RE: **Approval of Plans (REV 1)**
TDOT Gibson County Maintenance Building
1248 B Manufacturers Row
Trenton, TN 38382

TFM # 21267
Project # 2023-11-09-02
County: Gibson

Revision #1 Drawing Changes

4 SOUTH ELEVATION

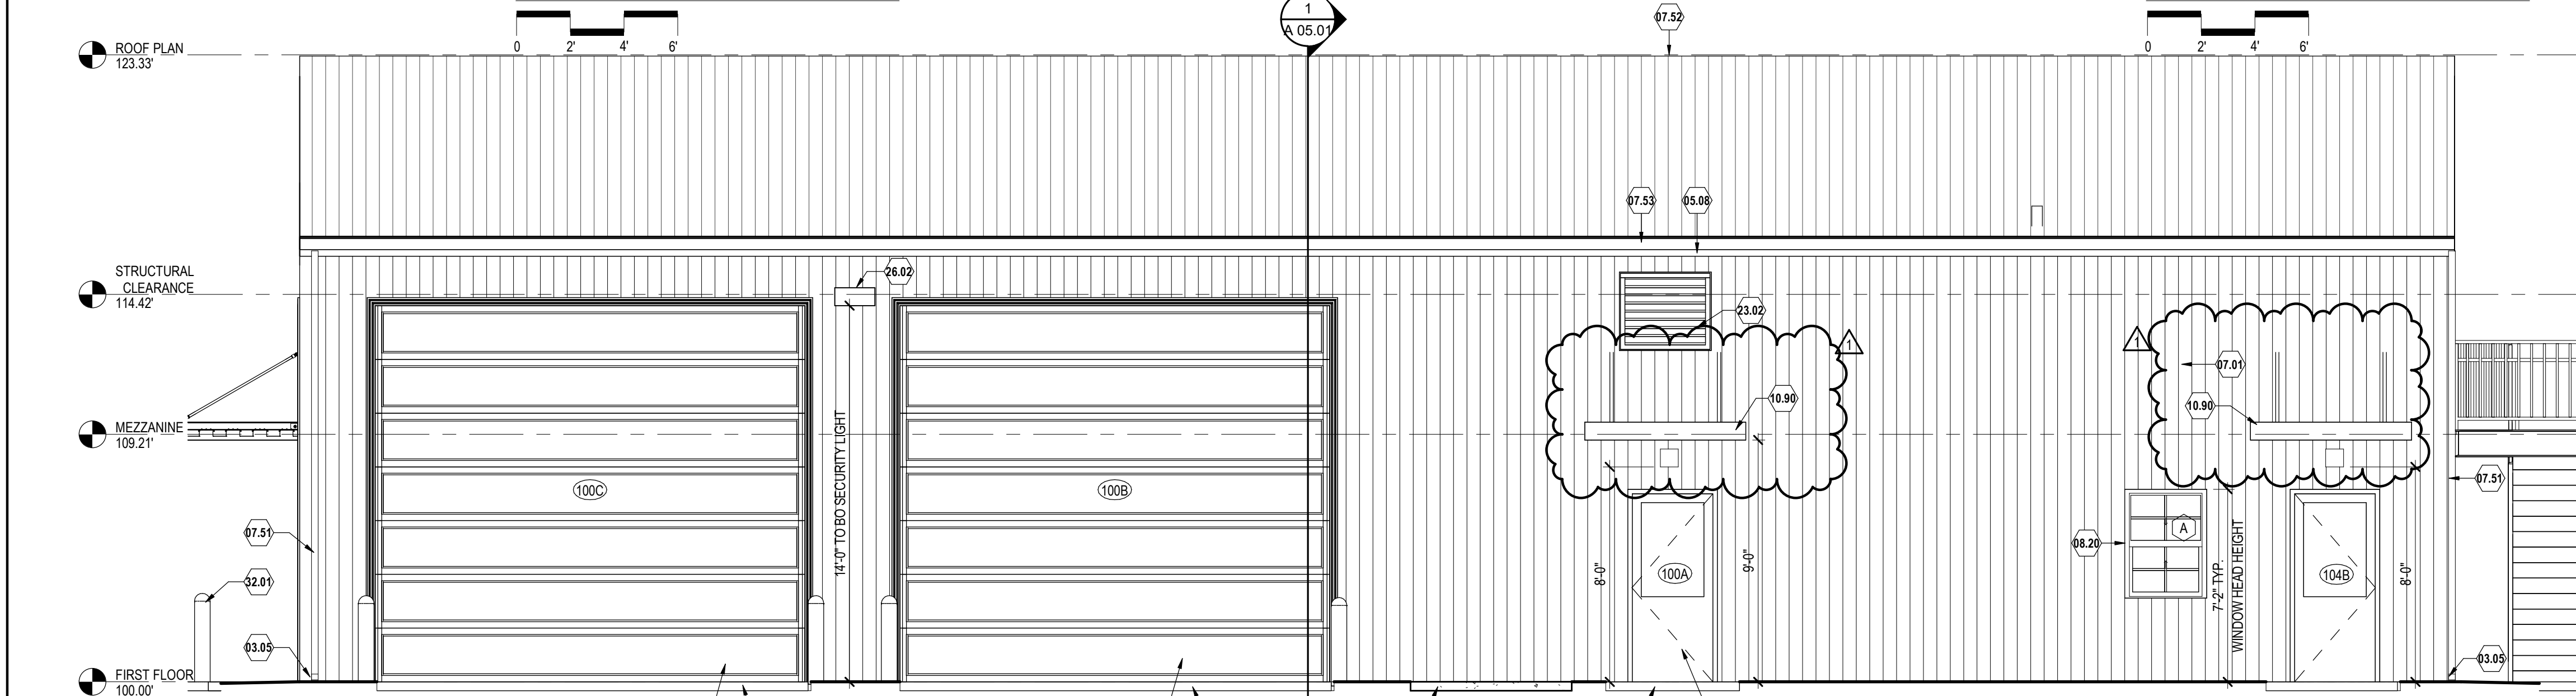
Sheet A04.01: Added canopies over doors on lower level, adjusted lights so that the same type was used over each door, removed louvers no longer needed, and moved one of the lights over the stairs.

A 08.02

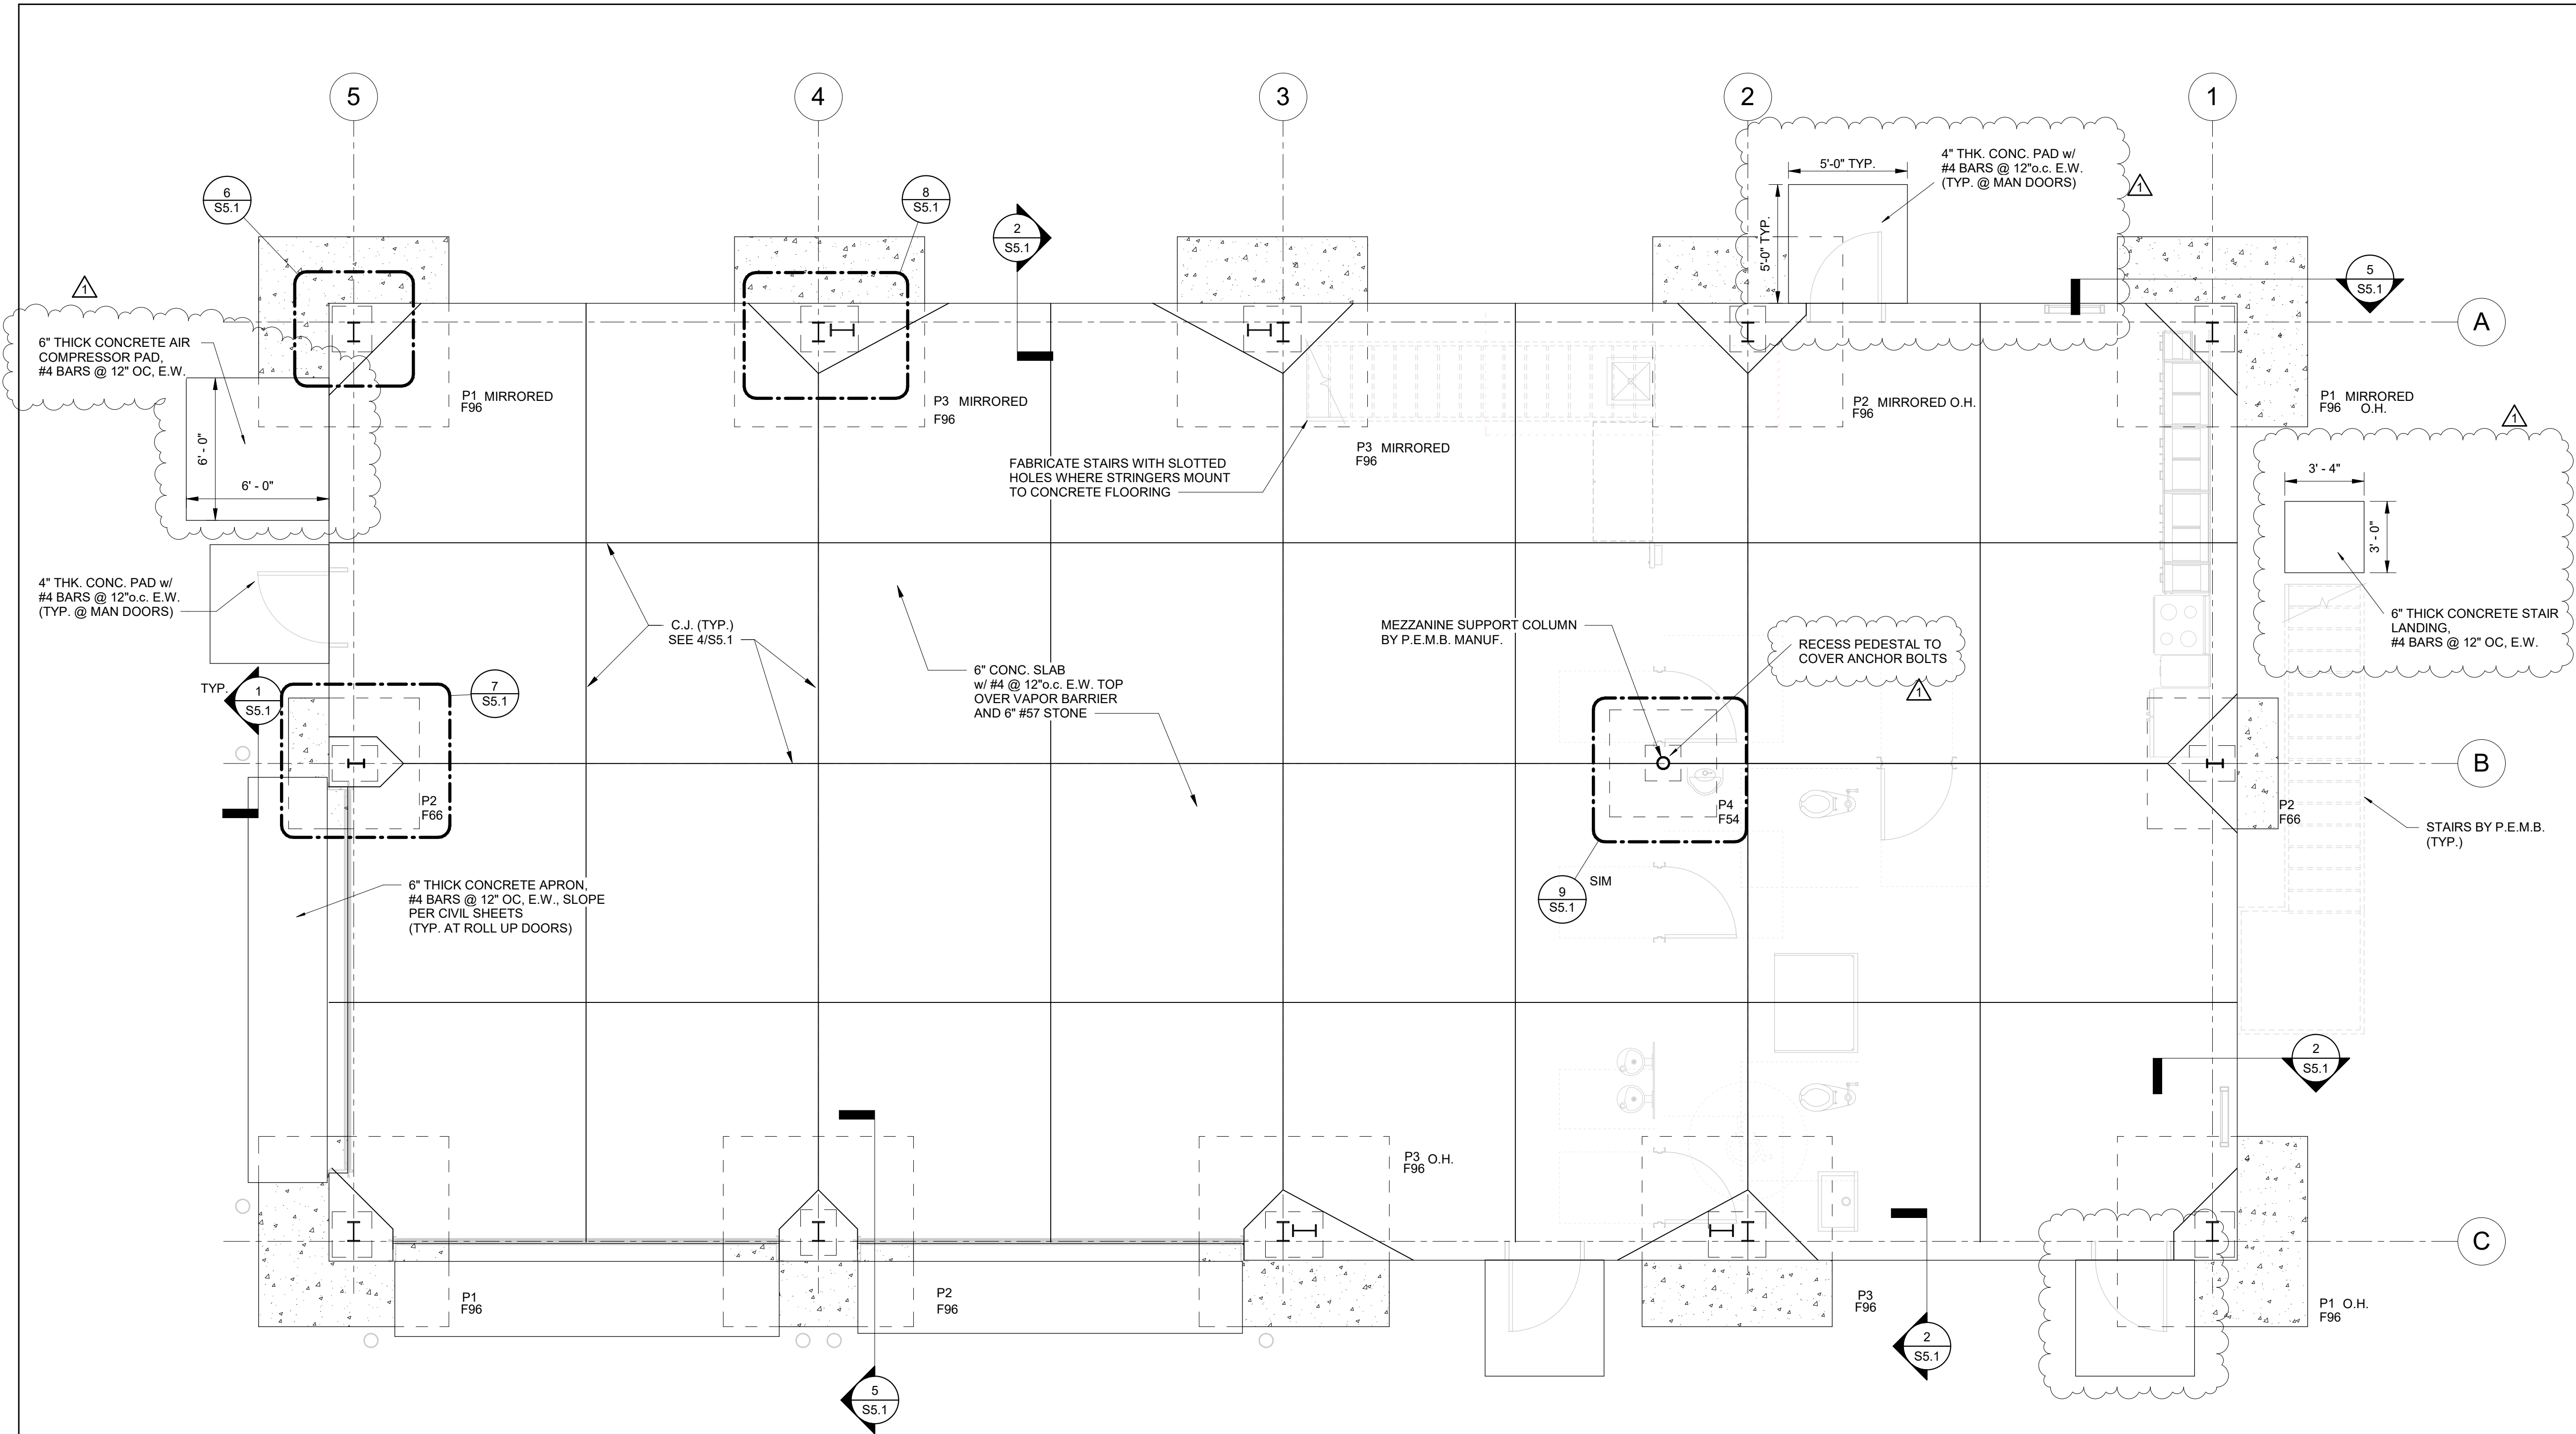
Sheet A08.02: Added details for handrails and epoxy flooring.

S1.0

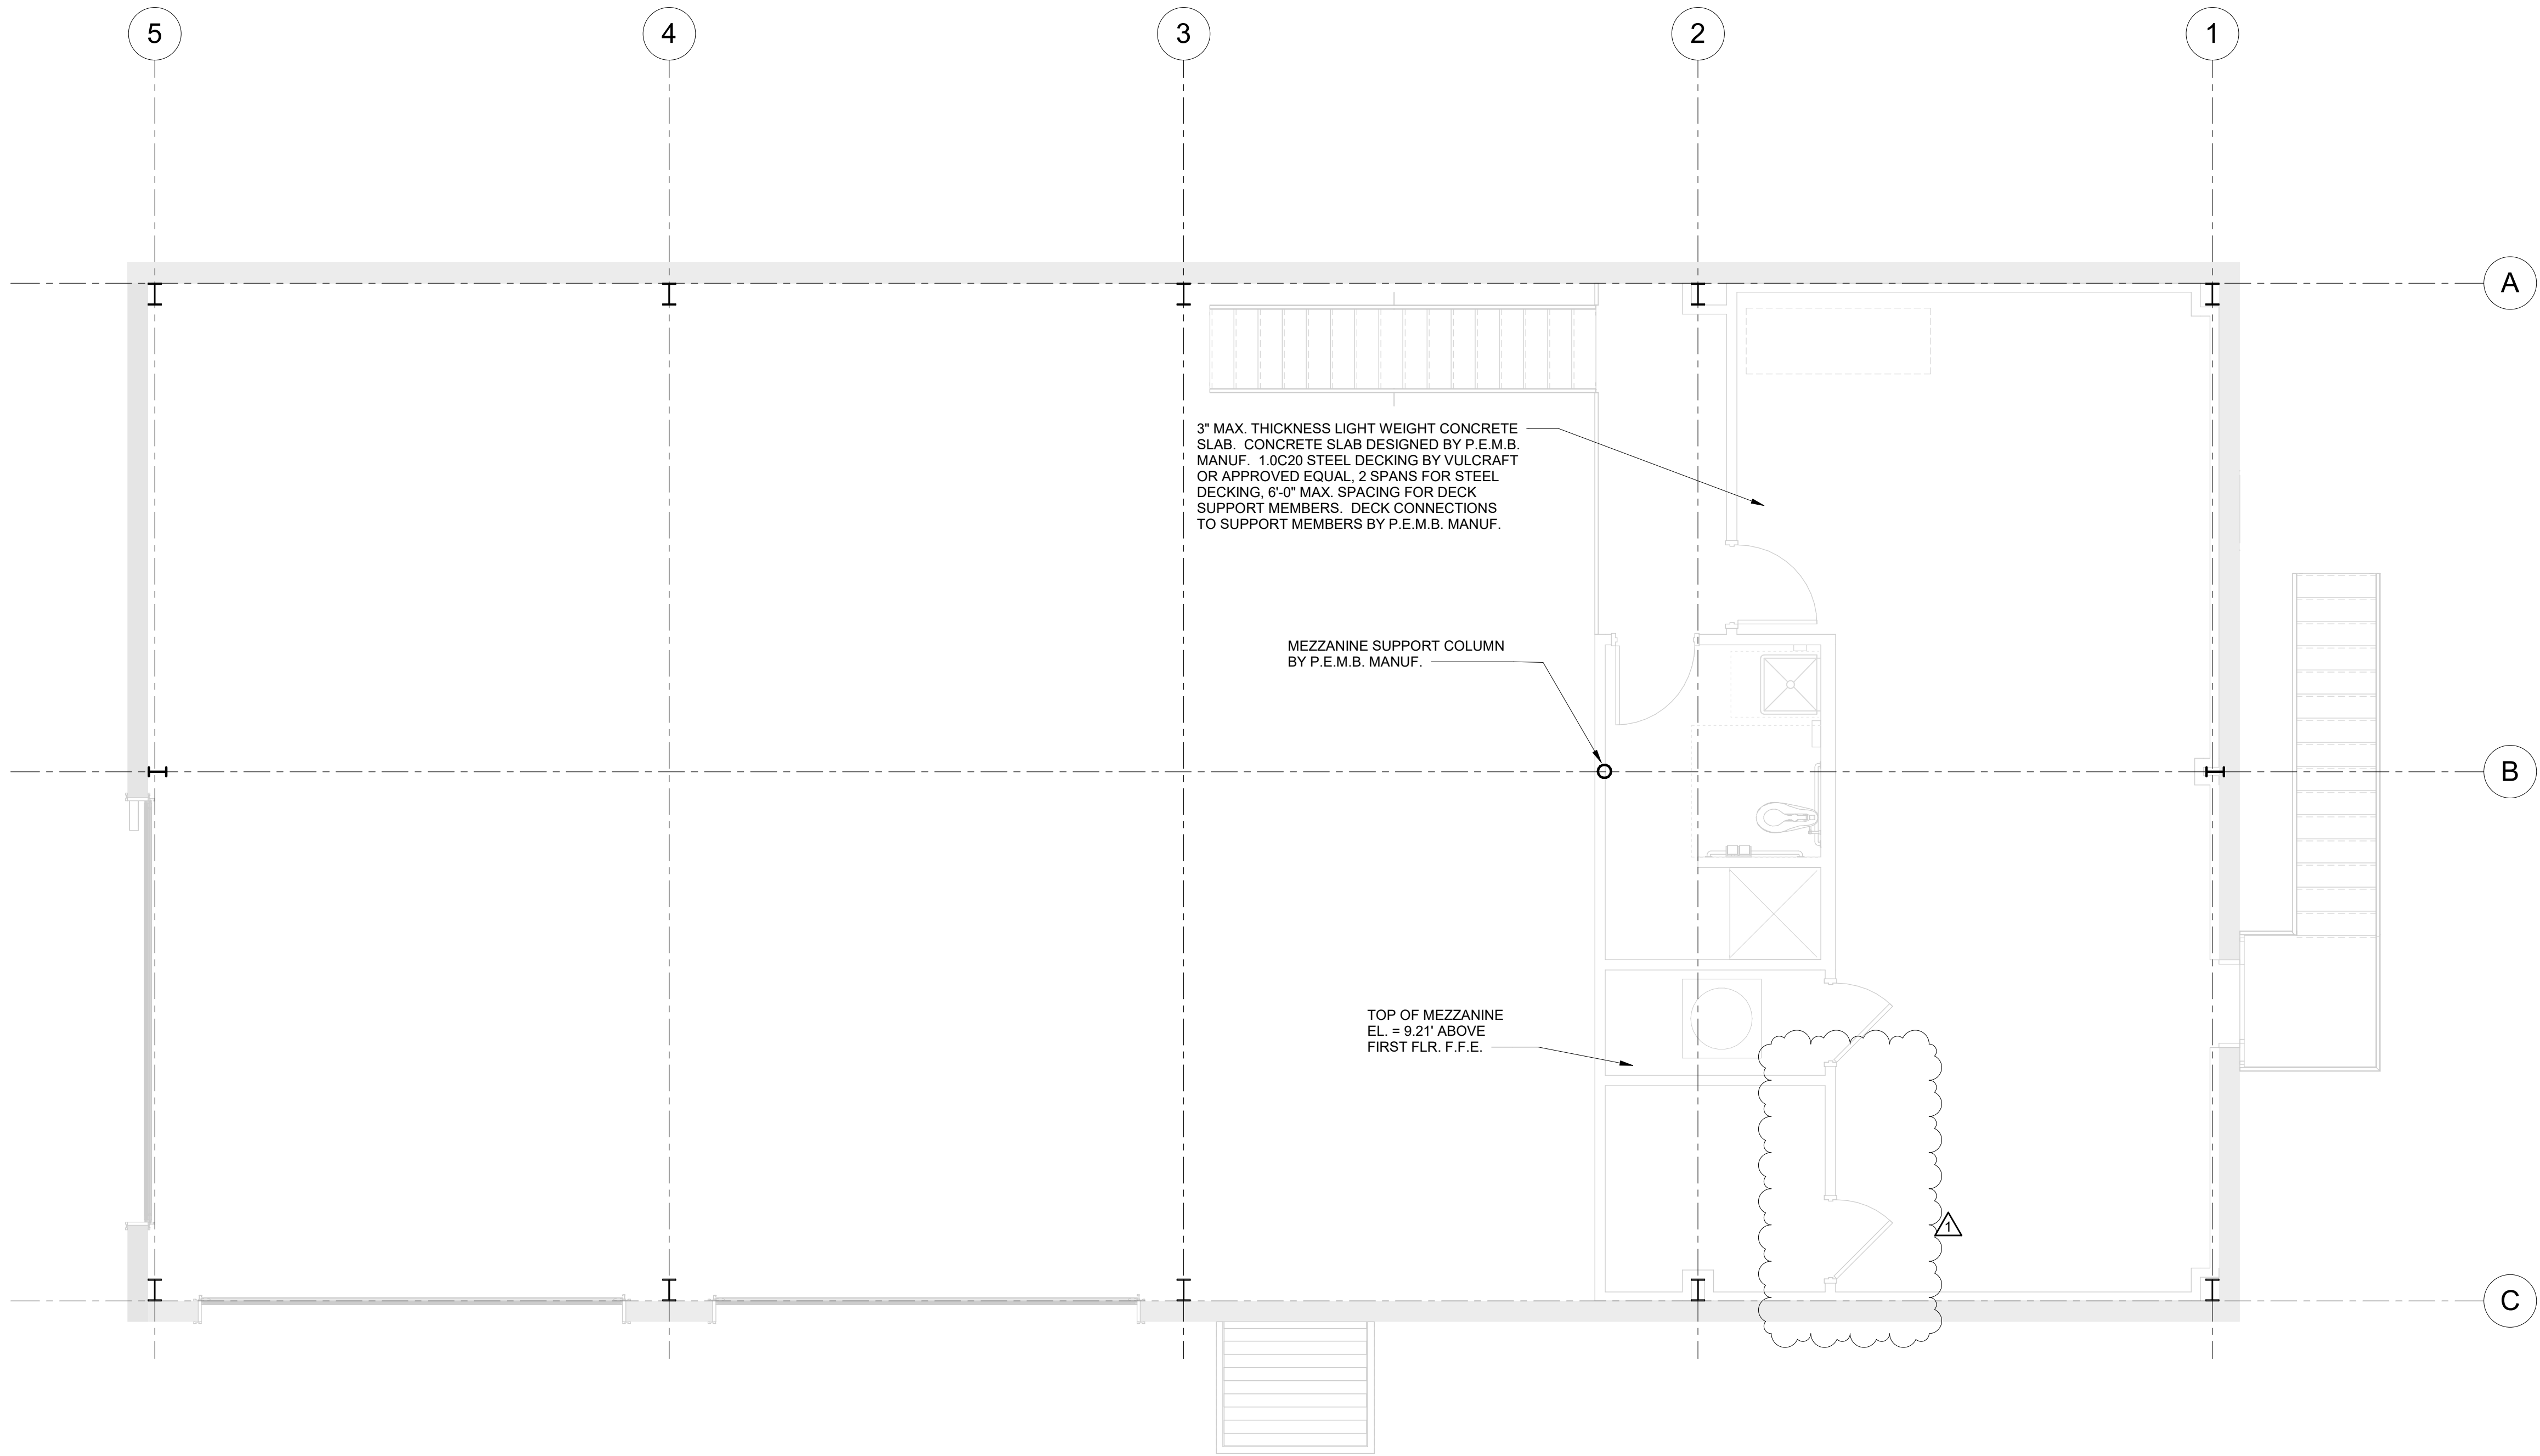
Sheet S1.0: Moved the compressor pad and added dimensions, added dimensions for stair landings and aprons at man doors, added a missing door apron, and added notes to the mezzanine baseplate location to recess the pedestal beneath the floor.
